### **LETTER OF CLARIFICATION NO. 1**

## NEW CITY HALL RENOVATIONS & RELOCATION PROJECT NO. E016015

DATE: January 10, 2022

G-203

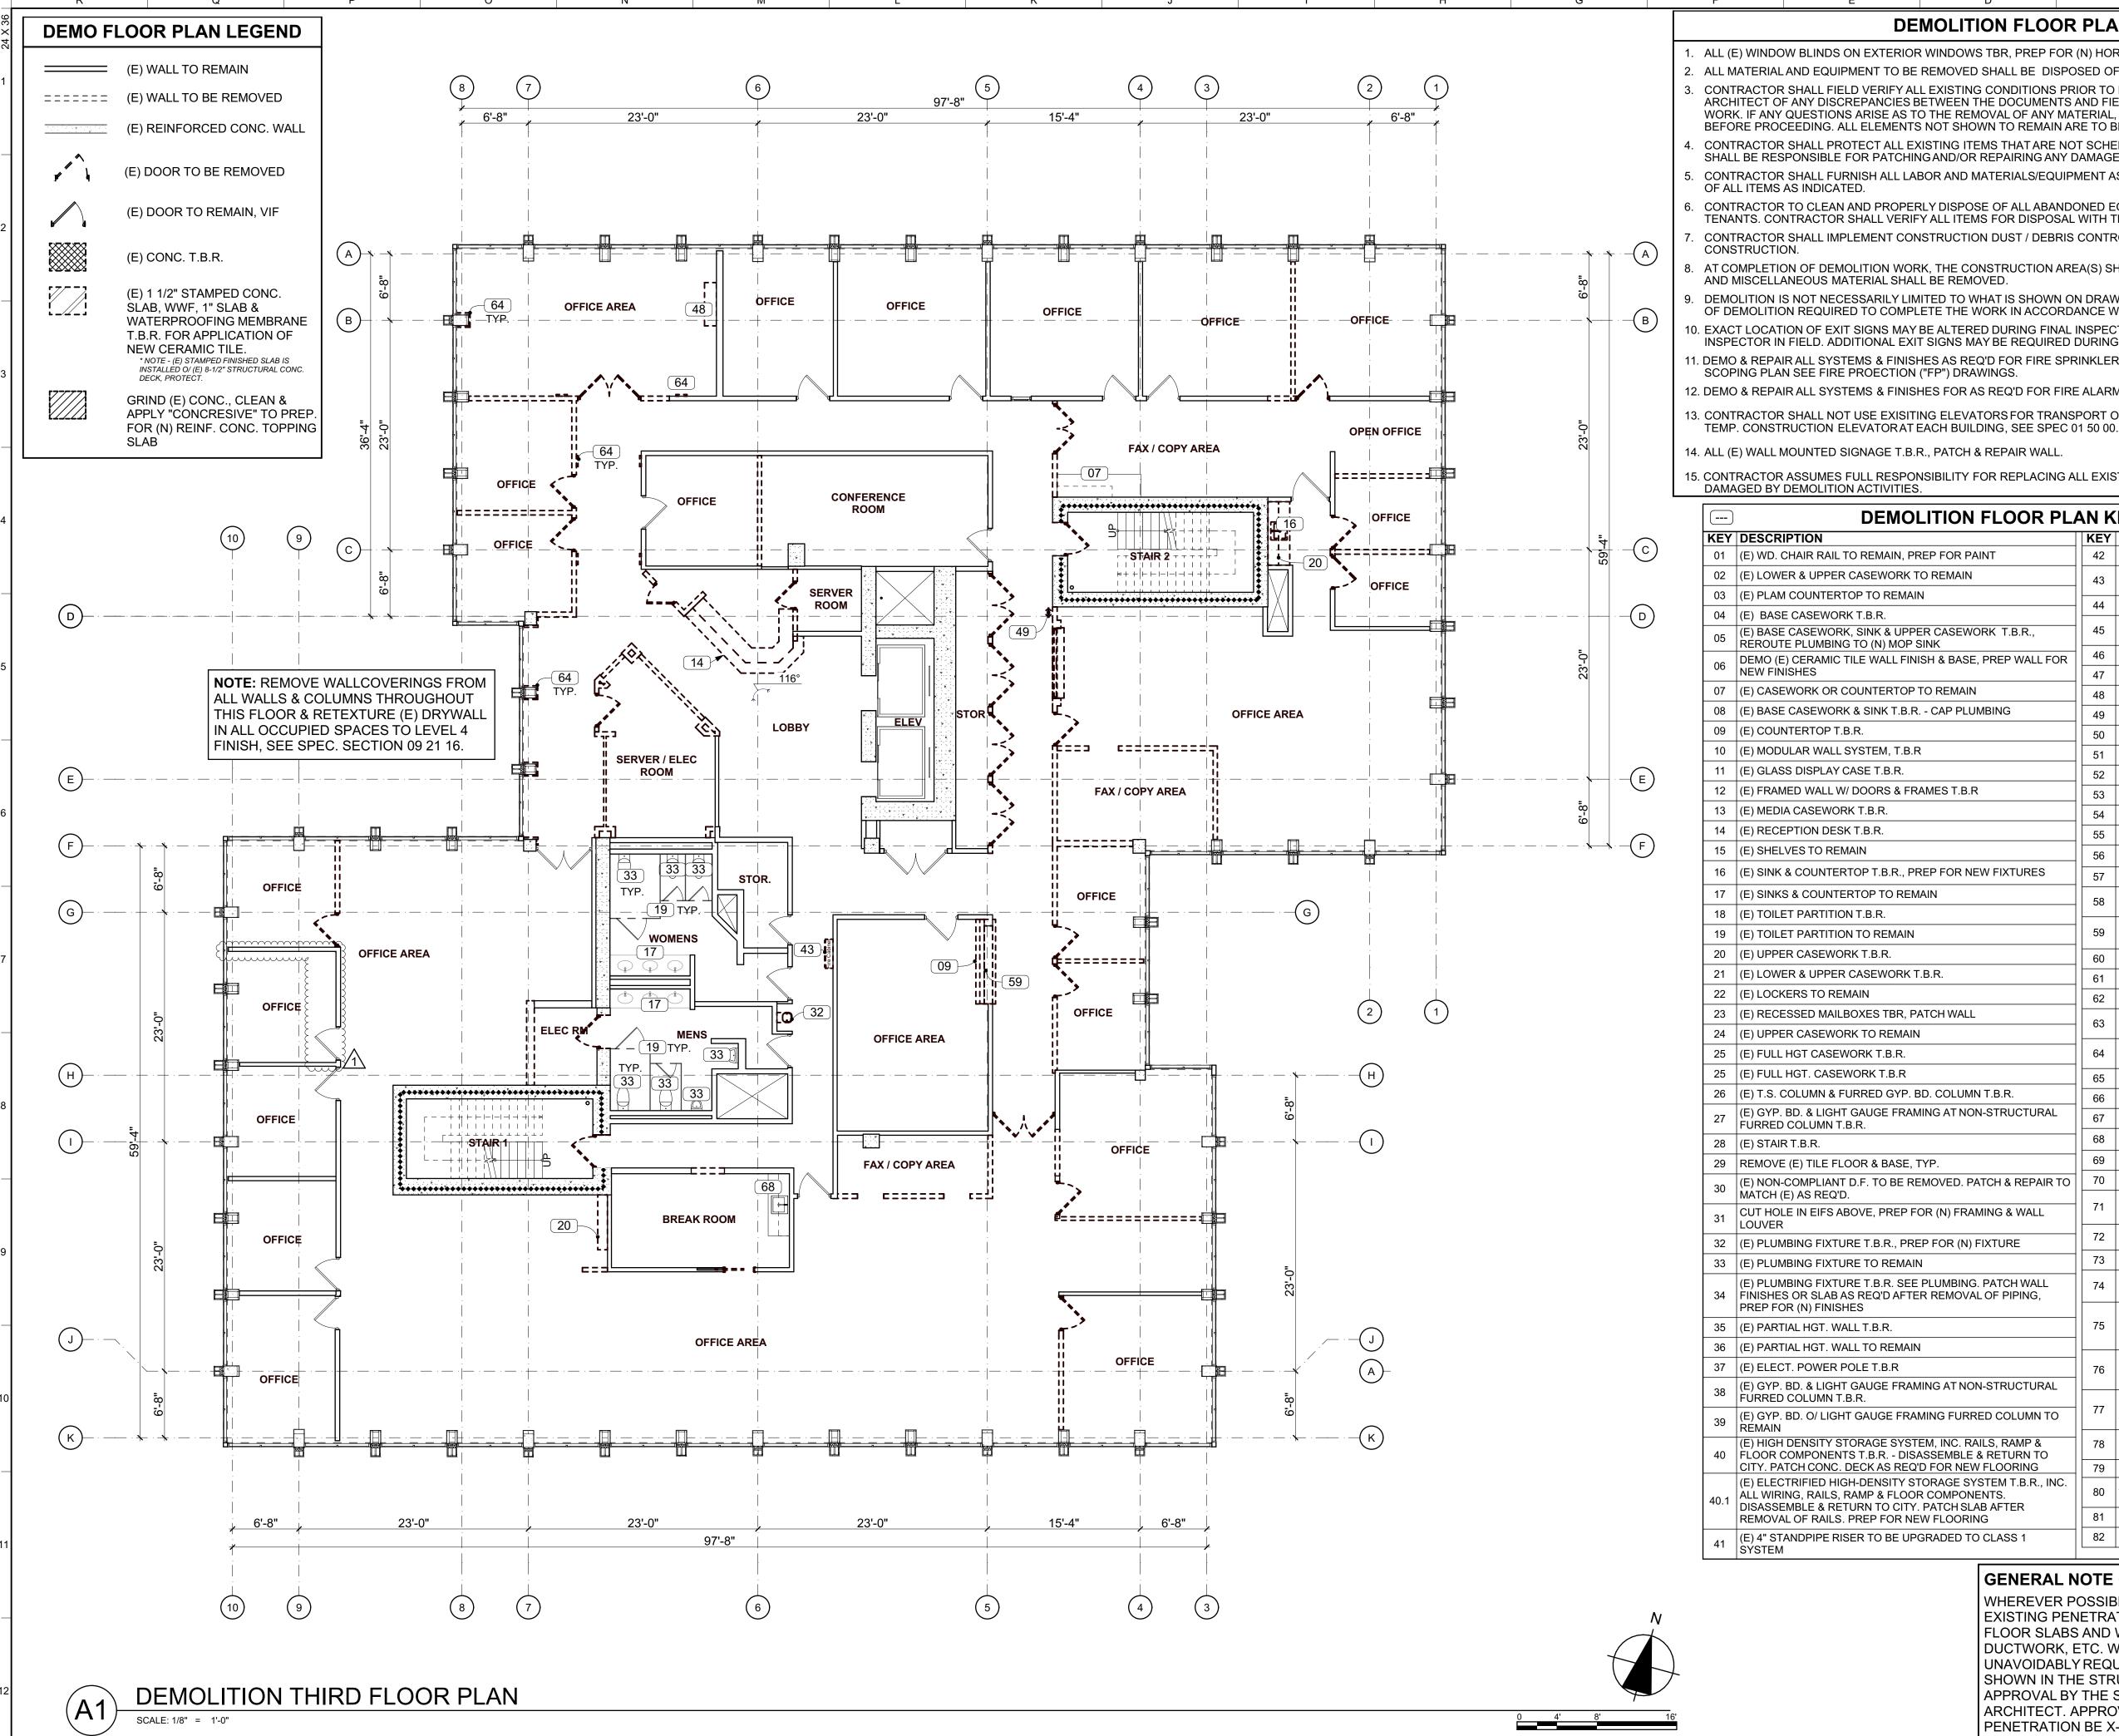
1. <u>Third Floor - Building 2 design revisions</u>: add Office 2-336B and Office 2-342B, including additional power, HVAC distribution and two (2) added doors. Delete

two (2) workstations in Open Office Traffic 2-344 and in Open Office Traffic Area 2-339 including revisions to power and data locations. Reconfiguration of workstations and relocation of copier south of Break Room 2-338 and in Open Office Traffic 2-339, including revisions to power and data locations. Add two (2) AV monitors in Office 2-320 and 2-322 including power and data provisions. Changes are marked by cloud with delta 1.

A. **Remove** the sheets listed below in their entirety and **Replace** each with the attached sheets of the same name:

G-201	Fire Life Safety Plan – First Floor Bldg. 1 & 2 & Site
G-203	Fire Life Safety Plan – Building 2
AD2-103	Demolition Third Floor Plan – Building 2
A2-103	Third Floor Plan – Building 2
A2-113	Third Floor Reflected Ceiling Plan – Building 2
A2-153	Third Floor Signage & Dimension Plan – Building 2
A-602	Door Schedule – Building 2
12-103	Third Floor Finish Plan – Building 2
IF2-103	Third Floor Furniture Plan – Building 2
MD2-103	Demolition Third Floor Plan – Building 2
M2-103	Mechanical Third Floor Plan – Building 2
PD2-103	Demolition Third Floor Plan – Building 2
	(*background change only, no change to scope)
P2-103	Plumbing Third Floor Plan – Building 2
	(*background change only, no change to scope)
ED2-203	Third Floor Demolition Plan – Electrical – Building 2
	(*background change only, no change to scope)
E2-103	Third Floor Remodel Plan – Lighting – Building 2
E2-303	Third Floor Remodel Plan – Electrical – Building 2

A2-153

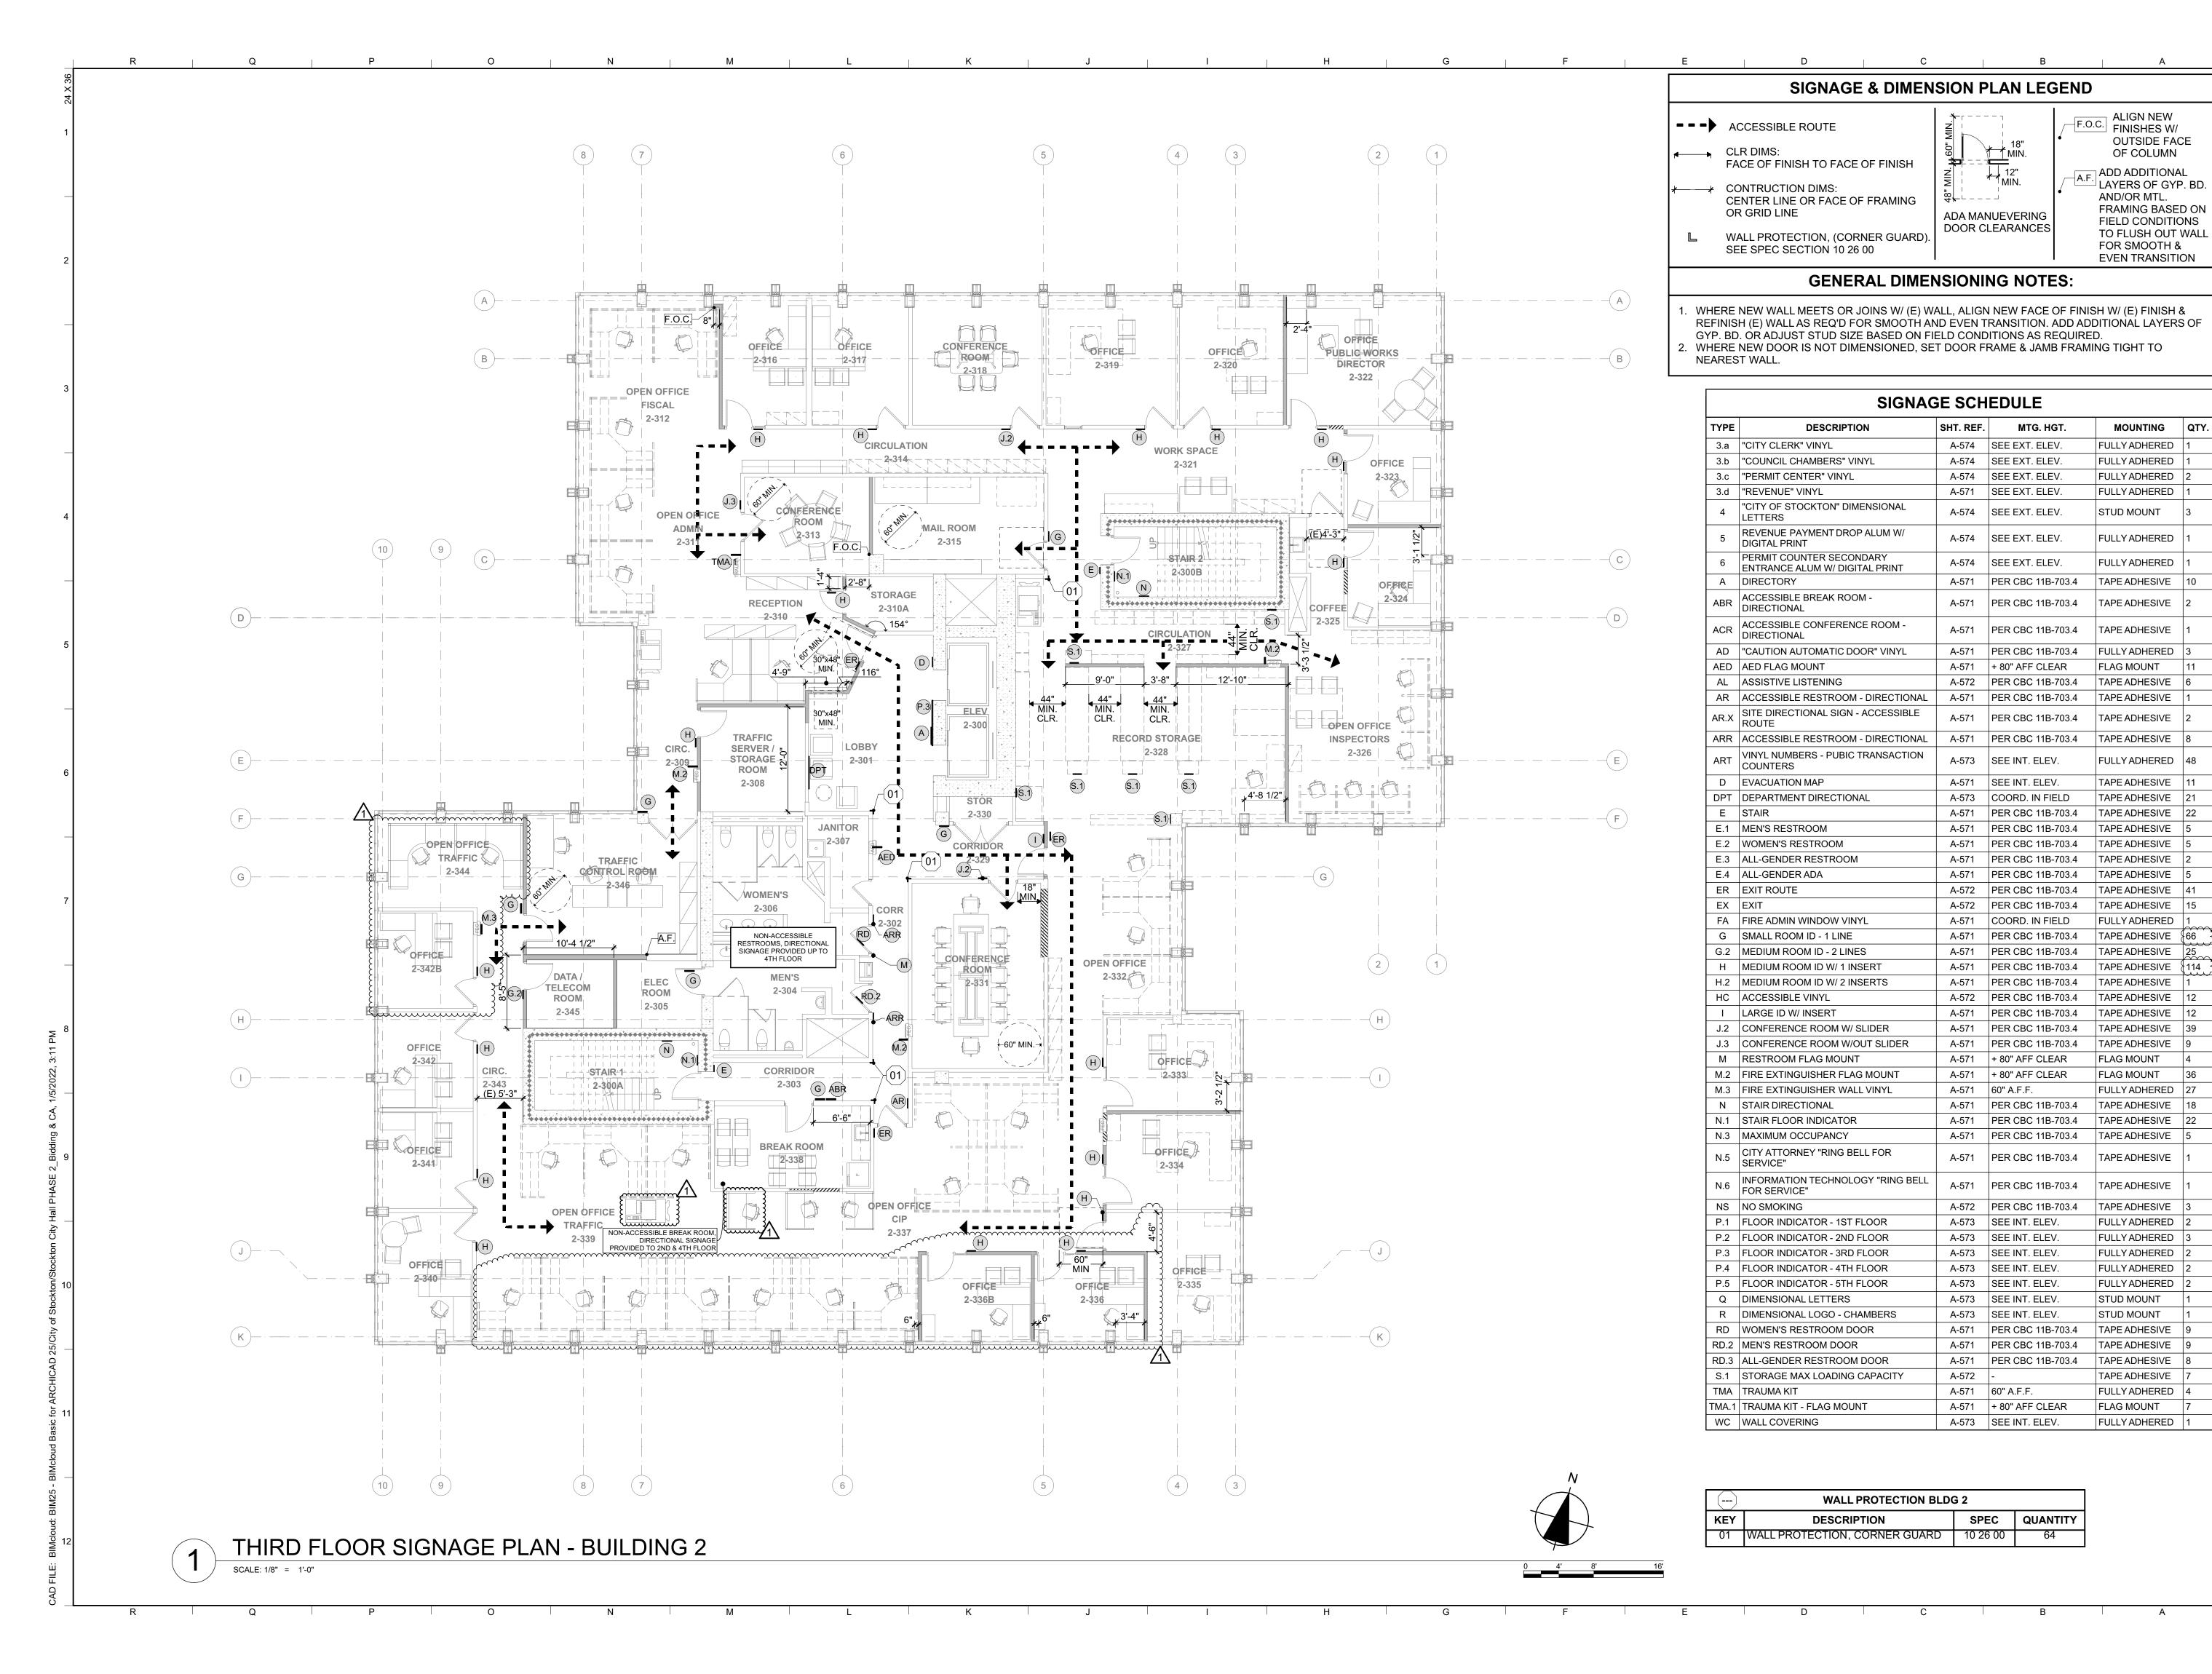
- Signage Schedules on all Signage and Dimension Plans Revise Sign Type G quantity from 67 to 66. Revise Sign Type H quantity from 112 to 114, see revised plan sheet A2-153 under Item 1 for locations. Sheets affected are: A1-151 through A1-155, A2-15B, A2-151 through A2-155.
- 3. <u>Sheet A-573 Specialty Signage Details</u> **Remove** this sheet in its entirety and **Replace** with the attached sheet of the same name. Signage dimensions added. Changes are marked by cloud with delta 1.
- 4. <u>Sheet A-574 Exterior Signage Details</u> **Remove** this sheet in its entirety and **Replace** with the attached sheet of the same name. Signage dimensions added. Changes are marked by cloud with delta 1.
